UNITED STATES PATENT AND TRADEMARK OFFICE

APPLICATION NO.	FILING DATE	FIRST NAMED INVENTOR	ATTORNEY DOCKET NO.	CONFIRMATION NO.
10/707,908	01/23/2004	Jason M. Benz	BUR920030121US1	1907

Office Action Summary

DETAILED ACTION

FIG 4A

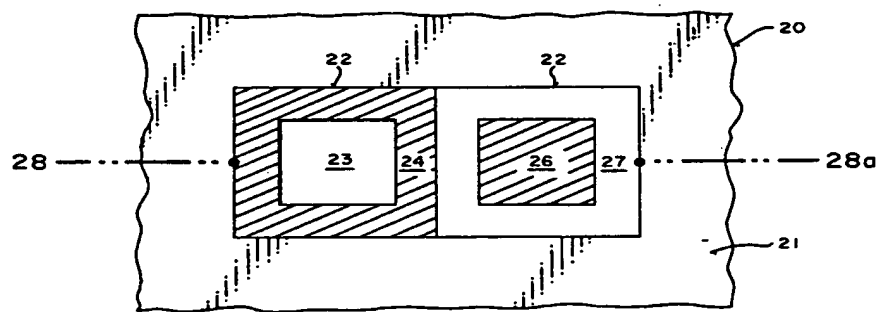
Dao et al. teach an inverted phase-shifted reticle or mask (PSM) having adjacent inverted phase features with PS rims or phase edges between 0° and 180° phase features; and methods of fabricating the PSM (title, abstract). The methods of fabricating the PSM include performing first patterning or etching of an opaque chrome (Cr) mask layer 21 (*instant claims 4 and 18*) formed on a transparent quartz substrate 20 (as shown in Figure 7, *instant claim 5*) to expose a first region of the transparent substrate 20, which is etched to form a PS region 53 first opening (Figure 8, which also corresponds to 24 in Figures 10 and 4A). This is followed by performing additional second patterning or etching of the opaque Cr layer to expose an adjacent second region 27 of the transparent substrate to enlarge the first opening formed in the first region 24 (*instant claims 2 and 16*) over a continuous area of the transparent quartz substrate (as shown in Figure 4A, which clearly depicts Figure 10 without any Cr between directly adjacent first region 24 and second region 27, col. 8 line 46 to col. 9 line 13, *instant claims 3 and 17*). In the PSM shown by Figure 4A, a first (etched PS) rectangular region 24 is directly adjacent to a second (unetched non-PS) rectangular region 27, in which both the first rectangular region 24 and the second rectangular region 27 are similarly shaped and sized (col. 5 line 67 to col. 8 line 3, *instant claims 1, 6, 15, and 19*).

Throughout the arguments on pages 9-18 of 19 in the amendment filed on 6/13/06, Applicant seems to have been confused regarding the order of process steps taught by Dao et al. for forming a PSM having a first PS region 24 (shown as 53 in Figure 8) and a subsequently formed second non-PS region 27 directly adjacent to 24 (as shown in Figure 4A), in which both

24 and 27 are rectangular regions with similar shape and size to each other. The teachings of Dao et al. have been further clarified above by a detailed description of these teachings, including copied images of corresponding Figures 4A and 7-10 from Dao et al. for Applicant's convenience. Applicant is specifically called upon to acknowledge that in Figure 4A there is no Cr covered region 21 at all between the first earlier formed PS region 24 and the second later formed non-PS region 27 (so that 24 and 27 are directly adjacent to each other without any separation in between them, as clearly illustrated in Figure 4A). Applicant's further description of Figures 11-25 on page 12 of 19 appear to be entirely irrelevant, because these other embodiments were not previously relied upon and are still not relied upon by the Examiner in the rejections set forth above.

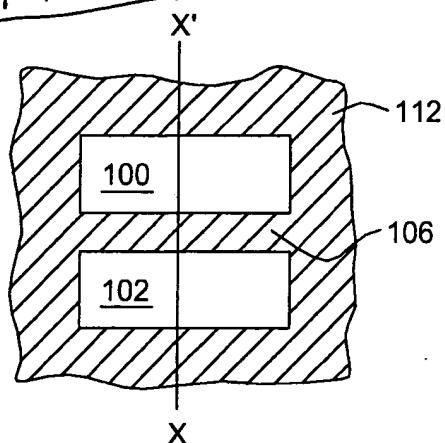
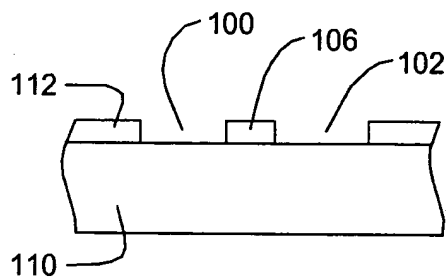
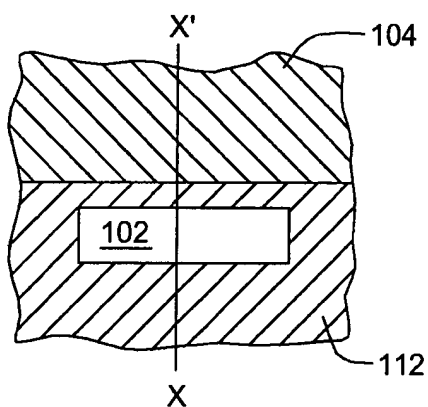
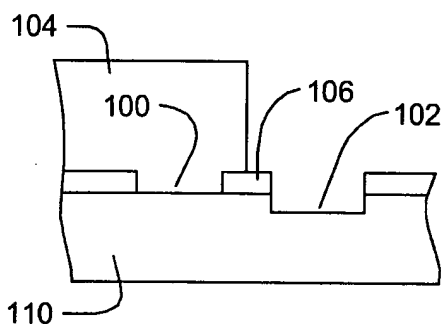
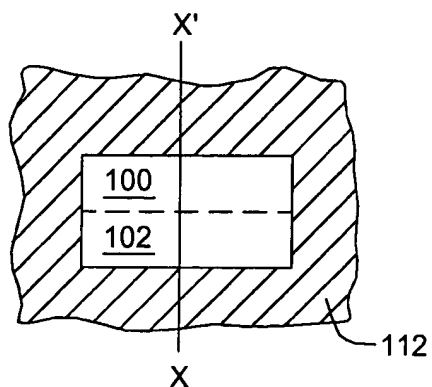
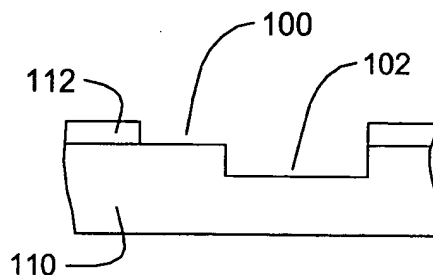
Figures 1A-3B should be designated by a legend such as --Prior Art-- because only that which is old is illustrated. Paragraph [0018] indicates that the instant invention is an improvement on the methodology illustrated by Figures 1A-3B (even if this methodology is not necessarily well known). See MPEP § 608.02(g). The replacement sheet(s) should be labeled "Replacement Sheet" in the page header (as per 37 CFR 1.84(c)) so as not to obstruct any portion of the drawing figures. If the changes are not accepted by the examiner, the applicant will be notified and informed of any required corrective action in the next Office action. The objection to the drawings will not be held in abeyance.
